Title: Advisory Committee on Reactor Safeguards
Subcommittee on Power Upgrades

Date: Thursday, April 27, 2006

The purpose of this meeting is to discuss the extended power uprate application for the R.E. Ginna Nuclear Power Plant. The Subcommittee will hear presentations by and hold discussions with representatives of the NRC staff and the Ginna licensee, Constellation Energy, regarding these matters.

Figure 2.8.5.3.1-3
Loss of Forced Reactor Coolant Flow - Frequency Decay
RCS Pressures and DNBR vs. Time

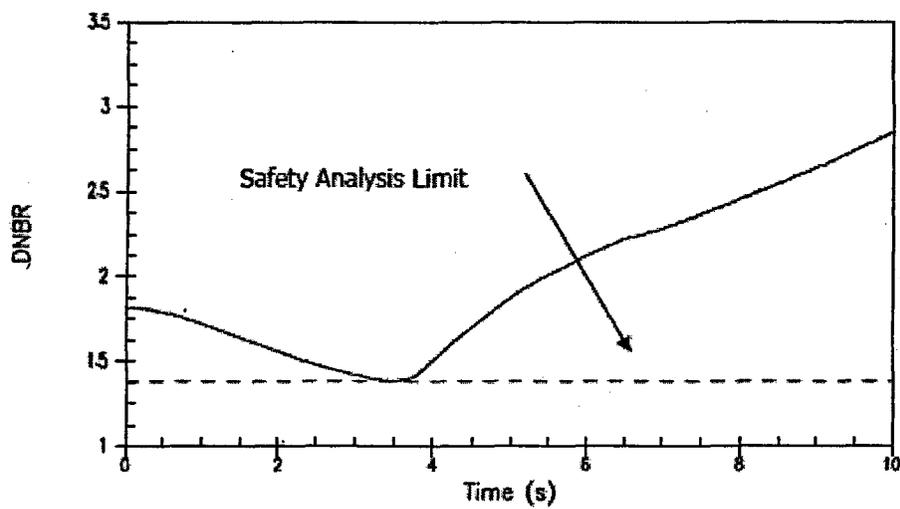
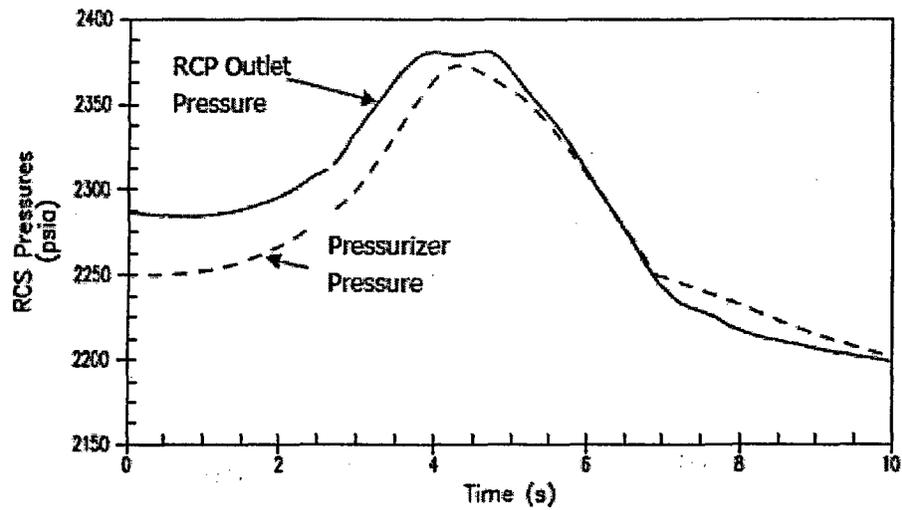
13 MR. WALLIS: Well, there's sort of two
14 questions that are basic. One is these numbers are
15 awfully close to the limit, and what does that mean?
16 And the other thing is RETRAN isn't a very accurate
17 code. You can tweak it various ways. When you get
18 2748.1, it would seem that the slightest tweak could
19 make it 2749.

2 CHAIRMAN DENNING: Well, I guess the only
3 question is that change that we just had where
4 yesterday we were looking at 1.55 and today we are
5 looking at 1.38, and the question is, what's the
6 smallest value that NRR will accept?

13 Right underneath the safety analysis
14 result we just modified one input to the analysis
15 associated with the trip time delay for loss of flow.
16 We used a conservative time in our analysis result to
17 get the 1.385. It was 1.4 seconds.

18 We have done one-time testing in the past
19 to demonstrate that result is actually less than one
20 second, and a more typical assumption for plants in
21 the industry is one second for other Westinghouse
22 plants.

1 performance, there's about a 3 percent change in the
2 result, as you see, 1.42.

Figure 2.8.5.4.2-7
 Rod Withdrawal at Power – DNB Case
 100% Power
 Minimum DNBR vs. Reactivity Insertion Rate

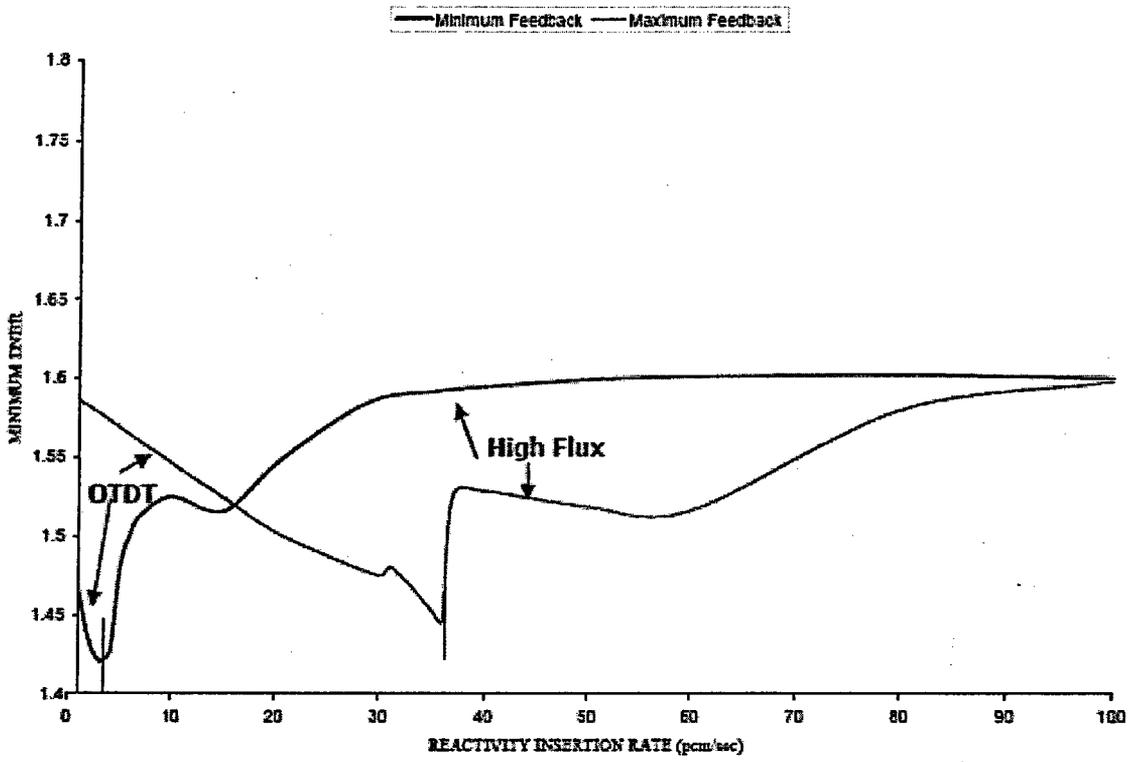
16 MR. WALLIS: I'm just trying to figure out
17 if there isn't a possibility that the rod withdrawal
18 rate somehow exceeds something that you have set to
19 it.

6 What Mark was saying is we refined the
7 reactivity insertion rates that we looked at to make
8 sure that we were getting the closest match to the
9 safety analysis limit. We analyzed a whole wide range
10 of reactivity insertion rates from like 1 pcm per
11 second up to, say, 110 pcm per second, which covers
12 the maximum differential rod worth you would expect to
13 see anytime in the core design life and also
14 associated with your maximum rod speed that you would
15 expect to see at the plant. Combining those two, we
16 cover the whole wide range of reactivity insertion
17 rates.

20 MR. HUEGEL: No. The other thing is we
21 don't limit the insertion either. I mean you have a
22 limited amount of bank worth that you can add in terms
23 of reactivity. What we assume in this transient is
24 that we keep adding whatever amount of reactivity it
25 takes us to get us up to the trip condition.

4 Keep in mind that we analyze a whole wide
5 range of reactivity insertion rates which conceivably
6 would cover a whole wide range of differential rod
7 worths and rod speeds. So we have encompassed any
8 particular rod speed that you could have at the plant
9 and also we have bounded any particular differential
10 rod worth that the core design would calculate, which
11 is confirmed on a cycle-by-cycle basis.
